ADDENDUM # 11

WEGO Transit and Fleet Operations Center Expansion

Request for Proposal No: RFP-22-2024-AD
Issue Date of Addendum: January 17, 2025
Proposal Submission Deadline: January 24, 2025 at 2:00 p.m. ET

ADDENDUM No.3

A7-300

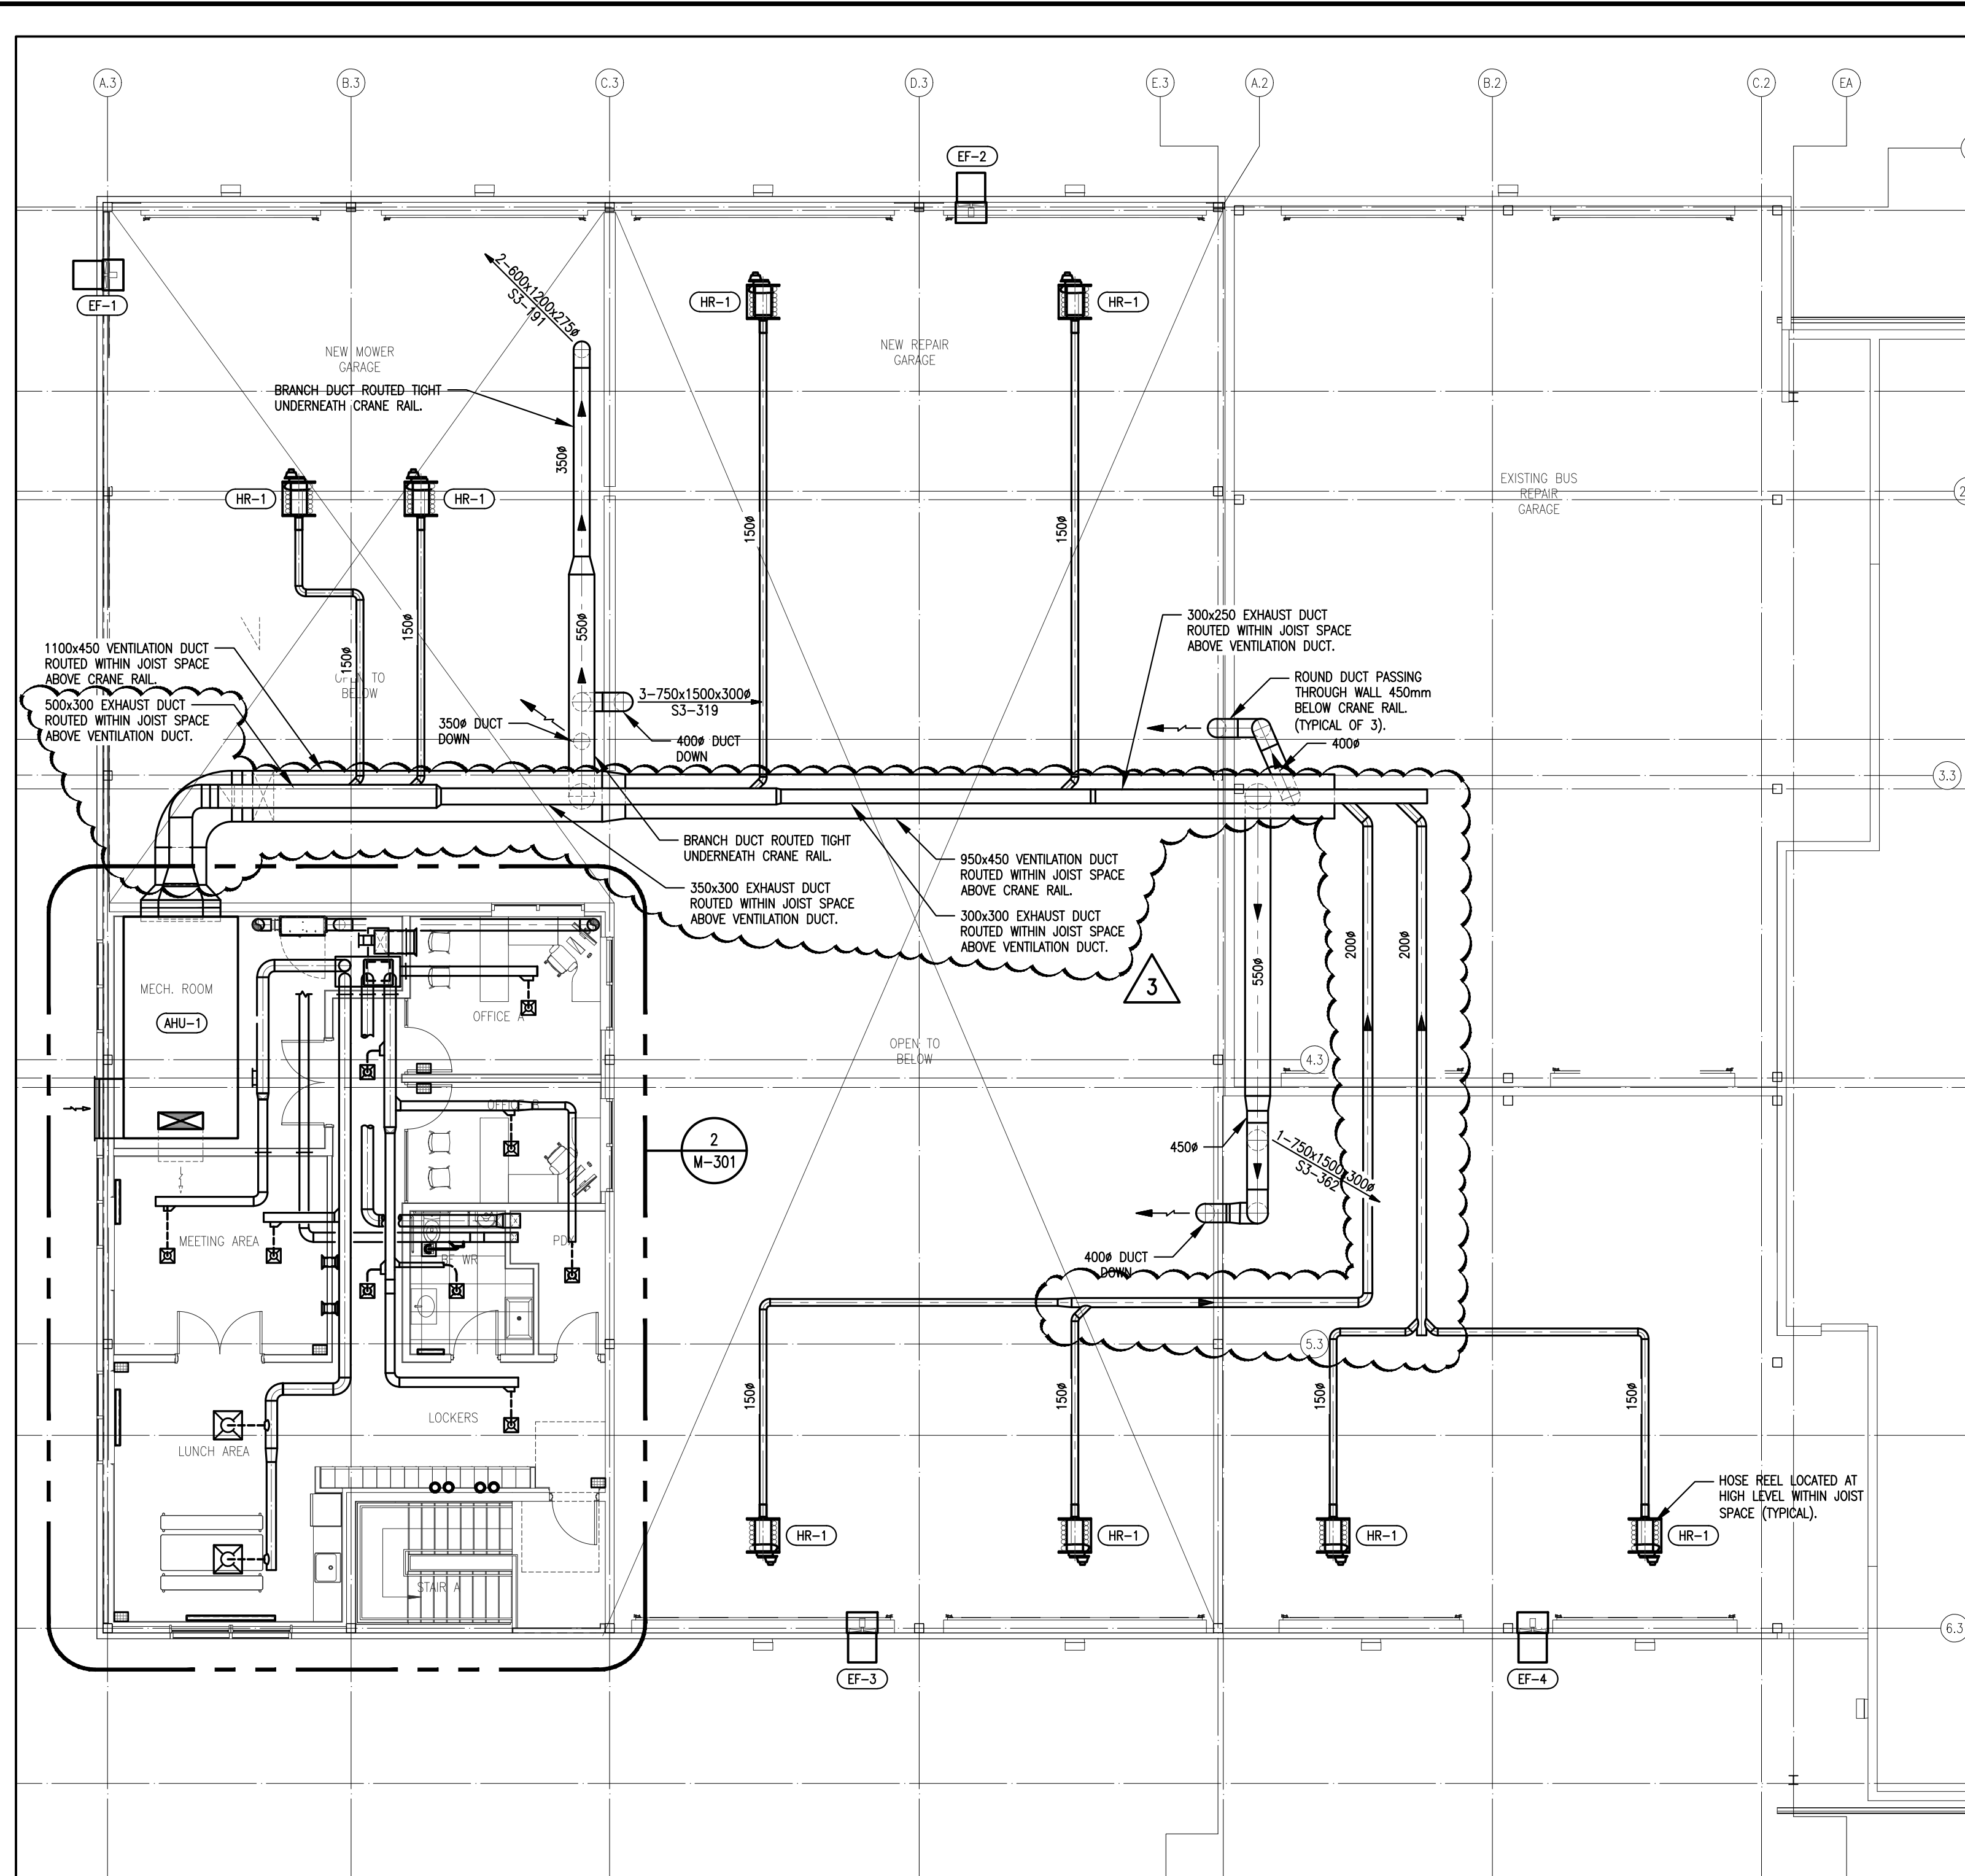
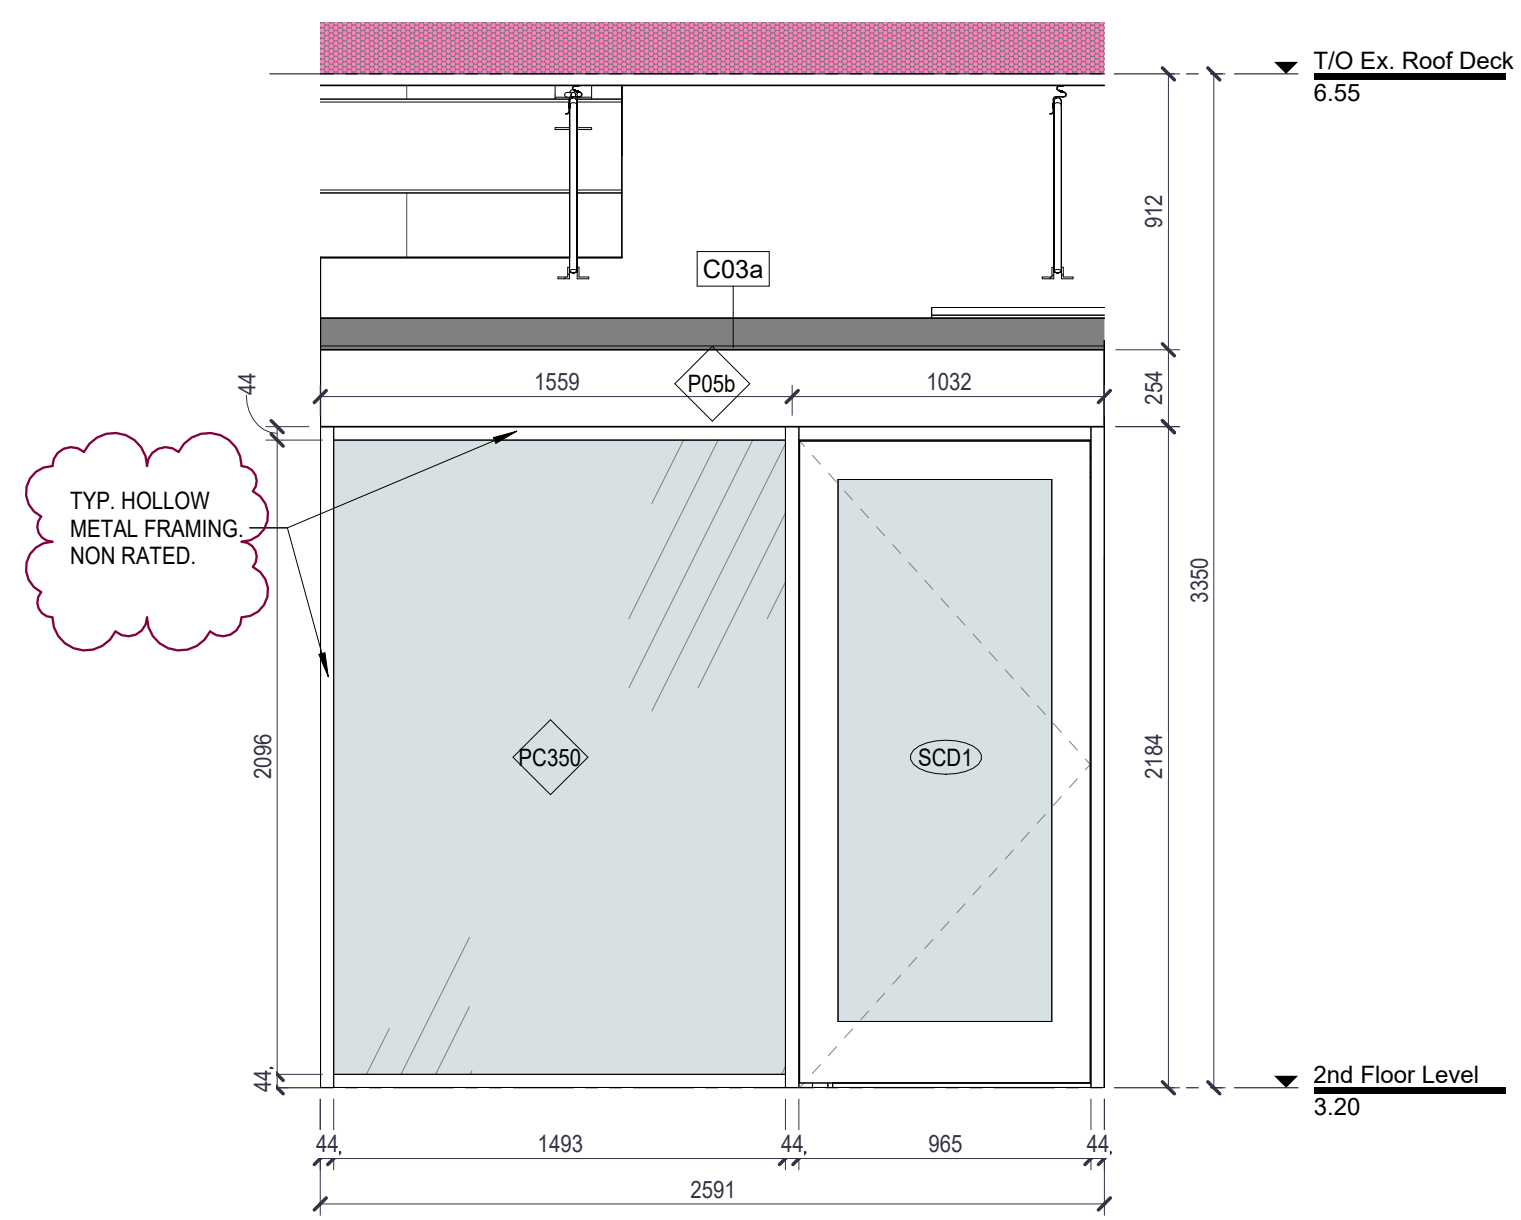
14. Further to addenda # 9 item 3..... " I just read addendum 9 and the response in regard to SC1. The architect describes this as a fire rated screen (an aluminum frame and fire rated glass, 60 minutes of protection required)

15. Please confirm what type of fire rated aluminum frame is required. Typically these screens are specified as hollow metal for economy. Aluminum clad steel fire rated frames are very expensive.

ANSWER: Hollow metal frames are specified, per Raimondo addendum 2.

ANSWER: Hollow metal frames are specified, per Raimondo addendum 2.

* = FIRELITE FIRE RATED GLASS, MIN. 60 MINS.
GC TO COORDINATE SHOP DRAWINGS
FOR REVIEW AND COORDINATION.
